Proposed realignment of West Coast Highway at south City Beach

City of Perth

**Report and recommendations
of the Environmental Protection Authority**

**Environmental Protection Authority
Perth, Western Australia
Bulletin 655
October 1992**

Figure 2: Proposed realignment options A, B, C and G.

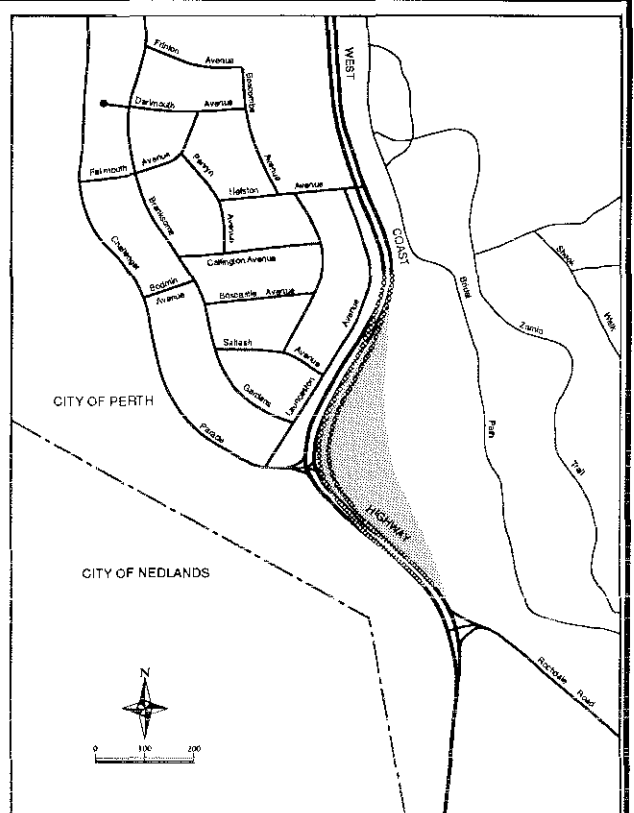
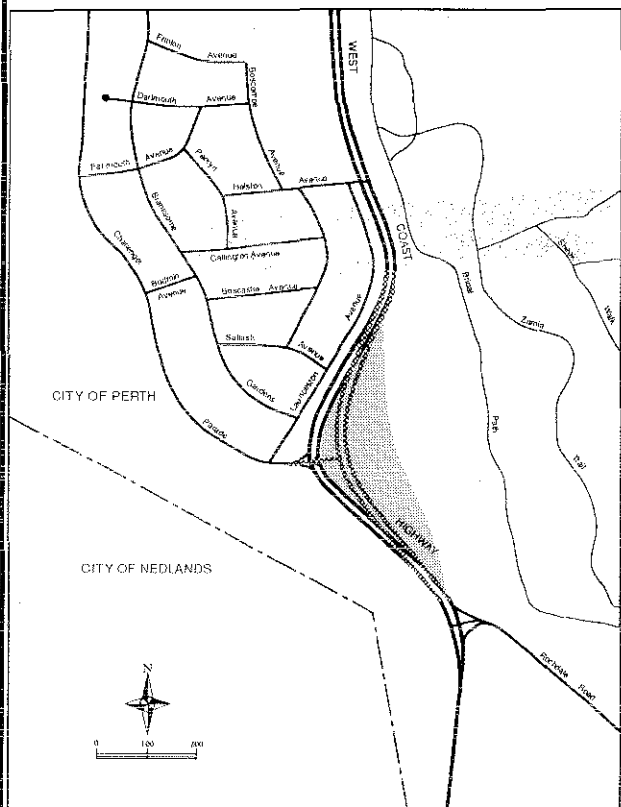
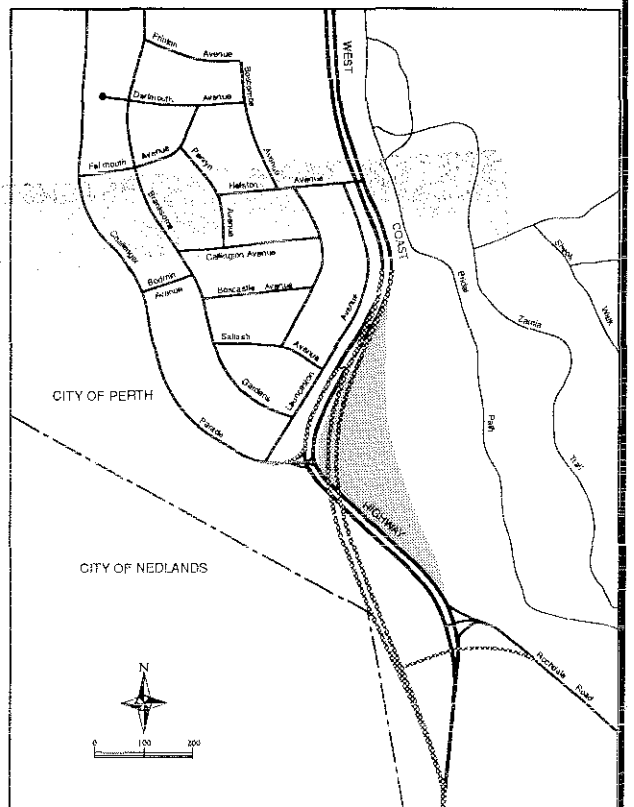
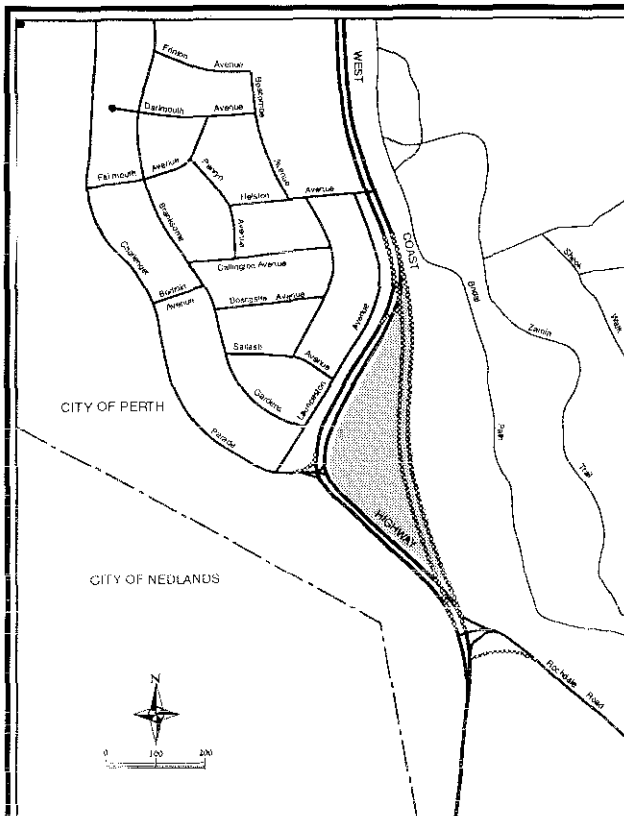
In this suite of options, the alignment of West Coast Highway would be moved only slightly onto the western edge of the Quindalup Dunes within Bold Park (Figure 2). Most of the affected Quindalup Dunes area has been degraded by previous road works. In addition, the Highway will remain outside of the bushland view-scape from Bold Park. Noise impacts to Bold Park should not increase markedly because of buffering from dunes east of the alignment. Additional road works are required to realign Rochdale Road through the Mount Claremont Bush portion of M46. However, the affected area is largely degraded at present.

Option B would require minor encroachment upon the Quindalup Dunes in Bold Park necessitating the removal of 1.2 hectares of vegetation. However, a large portion of the affected area is already degraded. To improve safety, construction of an earth bund (14 m base 2 m height) has been proposed which will provide a barrier between West Coast Highway and the South City Beach residential zone. An earth bund would have an adverse visual impact for nearby residents and road users. However, management initiatives such as rehabilitation of the current alignment and landscaping of the earth bund, could make this alternative environmentally acceptable.

Option C was commissioned by the Friends of Bold Park and prepared by Sinclair-Knight and Partners. The alignment is designed to meet the National Association of Australian State Road Authorities' guidelines for a design speed of 90 km/hr. Whilst this option requires the removal of 2.8 hectares of vegetation from the Quindalup Dunes of Bold Park, much of the high value vegetation is retained. The alienation of 4 hectares of land from the proposed Bold Park reserve would also be required; much of the affected 4 hectares has been degraded by previous road works. Rehabilitation of existing road alignments could reduce impacts upon the environmental values of the area. Configuration of the access roads should ensure that all vegetated areas are rehabilitated to link into the two reserve systems.

Option G aligns West Coast Highway beside the City of Perth boundary within the Rifle Range area (M46) and then through the degraded western portion of the Quindalup Dunes in Bold Park (M47) (Figure 2). This alignment meets the requirements of Main Roads (see Appendix 3). Almost 6.4 hectares of vegetation will be removed but, vegetation losses would be restricted to areas of M46 which are already degraded, or have lower regional value than areas within M47. A large scar would be created by earthworks required to re-contour two 42 metre dunes in the Rifle Range area along-side the City of Perth boundary. Stone pitching could be used to stabilise the affected dune area, pockets of vegetation could be used to reduce the visual impact.

The Authority considers that the impacts from alignment options B, C and G, upon the values recommended for conservation by recommendations M46 and M47 in the System 6 report, are potentially manageable and these alignments can be made environmentally acceptable.

The Environmental Protection Authority has concluded that Options A, B, C and G of the proposal to realign West Coast Highway at City Beach, as modified during the process of interaction between the proponent, the Environmental Protection Authority, the public and the government agencies that were consulted can be made environmentally acceptable.

3.1 Prior to the commencement of any site works for Option G, the proponent should conduct a study of the impacts upon landform and view-scape and implement the management requirements to minimise these impacts to meet the requirements of the Environmental Protection Authority.

3.2 Prior to the commencement of any site works for Options B, C, or G, the proponent should prepare a construction plan for the chosen realignment option, a rehabilitation plan for the site works and the current alignment, and dieback and fire management plans as indicated in the Public Environmental Review document.

Figure 3: Proposed realignment options D, F and E.

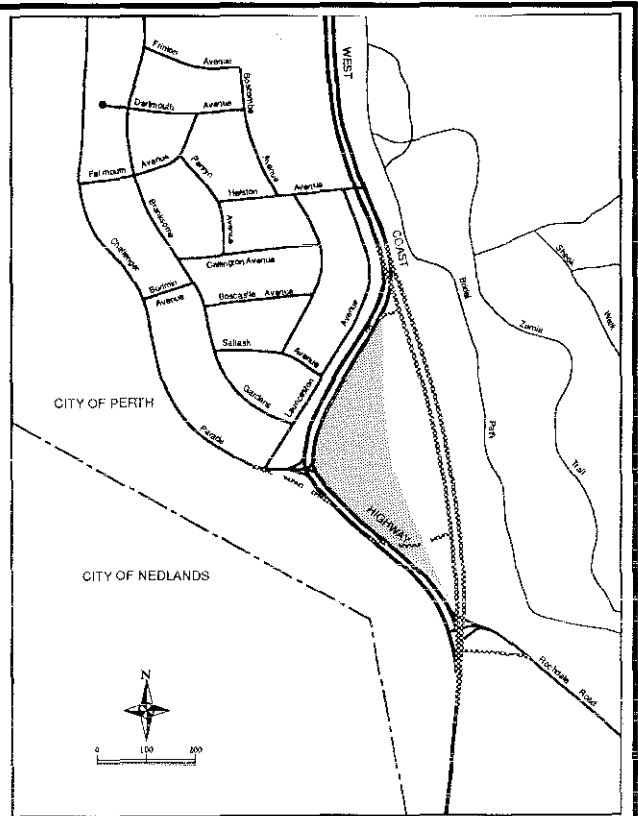
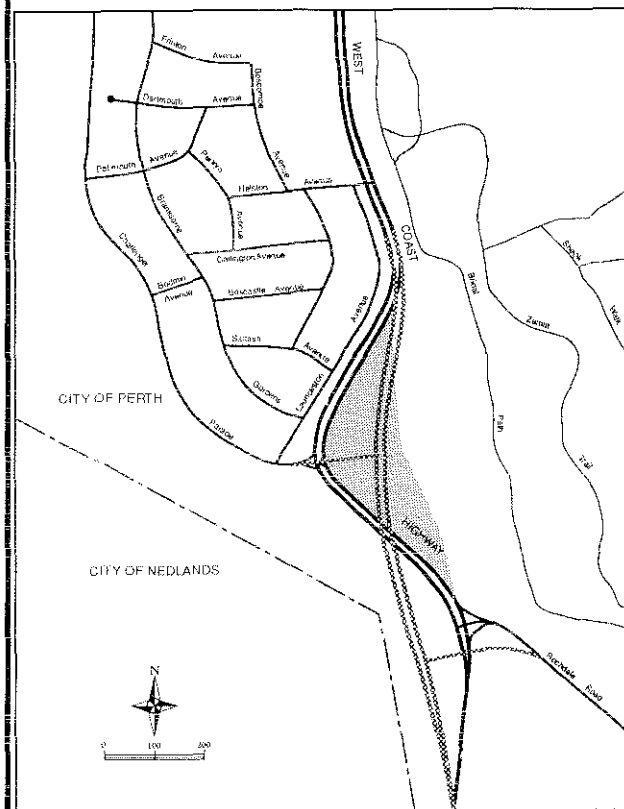
These options for the realignment of West Coast Highway would impact far more severely upon the highly valued vegetation associated with the Quindalup Dunes in the M47 recommended reserve (Figure 3) and upon the fauna and human use values of Bold Park.

Options D and F would result in destruction of a large portion of the Quindalup Dunes and associated high quality vegetation. Destruction of the Quindalup Dunes, which includes some significant species (including peppermint, Wembley wax and the large community of wattle *Acacia rostellifera*) is considered to be environmentally unacceptable and avoidable within the context of alternative options which are acceptable to Main Roads. Impacts upon vegetation caused by cutting off a large portion of Bold Park, as required by Option E, could be reduced through linking the severed portion with the Swanbourne Beach and Rifle Range areas, creating a reserve which also provides continuous public access from Perry Lakes to the coast. However, extensive rehabilitation, ongoing monitoring and management would be required to link these two areas. Unfortunately, as previous road works have led to deterioration of the vegetation next to the Highway and feeder roads, substantial effort would be required to rehabilitate the vegetation associations. Additionally, weed removal and summer irrigation would be an ongoing requirement to ensure that rehabilitation efforts were successful.

Option E would severely impact upon the value of Bold Park as a large reserve, causing unacceptable threats to the maintenance of the rich and diverse reptile and bird fauna of Bold Park, and intrude upon the quietness and views of the bushland. Whilst rehabilitation has the potential to restore vegetation, realignment as indicated in Option E would cause severe disturbance to fauna which is reliant upon the substantial area of continuous bushland to maintain sustainable populations. Breaks in habitat such as roads, constitute barriers to the distribution and movement of fauna (Barnett, How and Humphreys, 1978). The high volume of traffic carried by West Coast Highway will restrict fauna movement between the reserves. Even an underpass would constitute a physical difference in the landform leading to the formation of an identifiable social boundary and restrict movement of native fauna. The Environmental Protection Authority considers it unlikely that rehabilitation could redress the significant impacts to the highly valued fauna of Bold Park, caused by severing land from the ecological refuge of the park.

Locating the Highway through the Quindalup Dunes in Bold Park, as in Options D and F, or further east, as required for Option E, would severely impact upon the landforms, views, quietness and seclusion of Bold Park. It is apparent from the Public Environmental Review document and submissions that the public consider Bold Park to be the entire area recommended for reservation by recommendation M47 of the System 6 report. Whilst it may be possible to link the alienated portions of Bold Park with the Swanbourne Beach and Rifle Range (using an underpass), there would be substantial and unacceptable impacts, upon the human use values identified above, which could not be adequately managed.

The Environmental Protection Authority considers that Options D, E and F would have significant impacts upon the regional park values, and the highly valued flora, fauna and human use values of this area. No strategies have been developed during the environmental impact assessment process which will adequately manage these impacts. In addition, alternative alignment options acceptable to Main Roads (Appendix 3) avoid these severe impacts.

The Environmental Protection Authority has concluded that Options D, E and F of the proposal to realign West Coast Highway at City Beach, cannot be made environmentally acceptable due to the nature and severity of impacts upon regional park values, and the highly valued flora, fauna and human use values of the area and recommends that these alignments should be refused.
